DATE: February 6, 2015

FROM: The Schemmer Associates  
Architects-Engineers-Planners  
1044 North 115th Street, Suite 300  
Omaha, Nebraska 68154-4436  
Phone: (402) 493-4800  
Telefax: (402) 493-7951

RE: Addendum No. 1 to the Bidding Documents for:  
Stanton Tower Boiler Replacement  
Fremont Housing Authority  
Housing Authority Project No. NE100501-14-01  
Schemmer Project No. 06577.001

SHEET NO: SDM-01

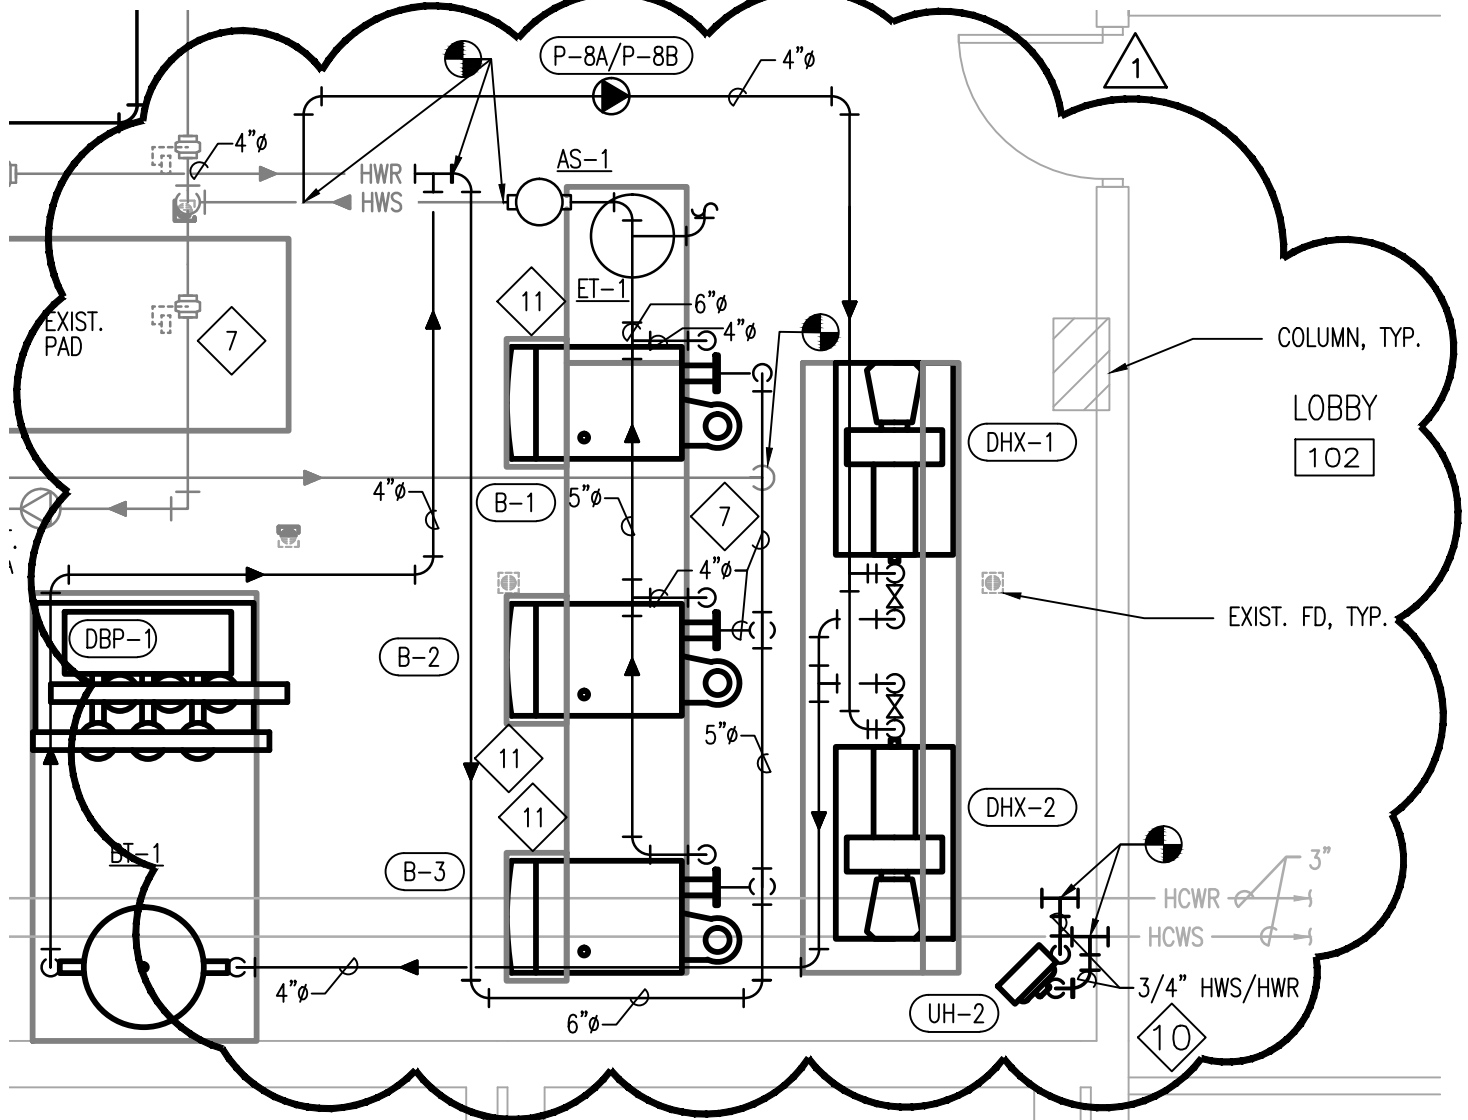
See supplemental drawing SDM-01 included with this addendum for HWS/HWR piping modifications and added Referenced Note #11.

11. MAINTAIN MANUFACTURER AND CODE REQUIRED CLEARANCES AROUND BOILER. ROUTE CONDENSATE DRAIN FROM BOILER TO NEAREST EXISTING FLOOR DRAIN PER MANUFACTURER'S RECOMMENDATIONS.
